DEPARTMENT OF THE AIR FORCE
AIR FORCE CIVIL ENGINEER CENTER

Subject: Response to WAFB – ADEQ Comments – ST012 – Discussion toward Extending
Steam Enhanced Extraction, Bioremediation (EBR) Transition,
Former Williams Air Force Based, Mesa, Arizona.

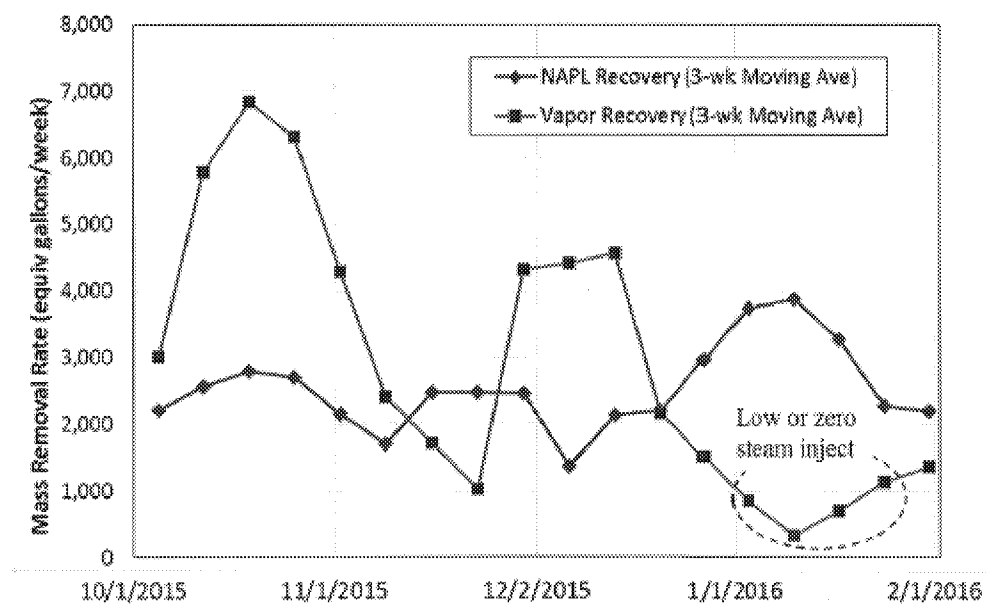
ADEQ does not consider pressure cycling a viable metric for transitioning to EBR. Pressure cycling has not improved mass removal of volatiles at ST012 during SEE based on the data presented (e.g., Slide 21 of the January 2016 Base Closure Team (BCT) ST012 presentation). While pressure cycling to improve the recovery of volatile contaminants dissolved in water has been demonstrated at other sites and has a firm scientific basis, the same cannot be said for volatile compounds dissolved in a multicomponent Non-Aqueous Phase Liquid (NAPL) dominated by heavier hydrocarbons. The lack of improved mass recovery in the vapor phase during pressure cycling suggests benzene mass remaining in the Thermal Treatment Zone (TTZ) is primarily dissolved in residual NAPL rather than dissolved in water. Benzene dissolved in residual NAPL is not treatable by EBR until it is dissolved into surrounding water.

Response: Pressure cycling was identified in the RD/RAWP as a transition metric. Pressure cycling has been demonstrated to enhance mass removal after steam breakthrough was demonstrated. Volatilization is one mechanism for enhancement by pressure cycling but not the only mechanism:

“For sites contaminated with semi-volatile or non-volatile chemicals, such as creosote, pressure cycling is used both to enhance vaporization of the lighter fractions of contaminants, and to induce mixing of injected steam and air with the contaminated groundwater. This may stimulate both dissolution of NAPL phases into the groundwater, and degradation reactions that take place under aerobic condition at elevated temperatures (HPO or biological degradation).” (USACE, 2009)

Lack of improved mass recovery in the vapor phase during pressure cycling more likely suggests that the perimeter contribution is greater than and hides the contribution from the TTZ interior. Benzene depletion from the NAPL by dissolution into the groundwater is the primary
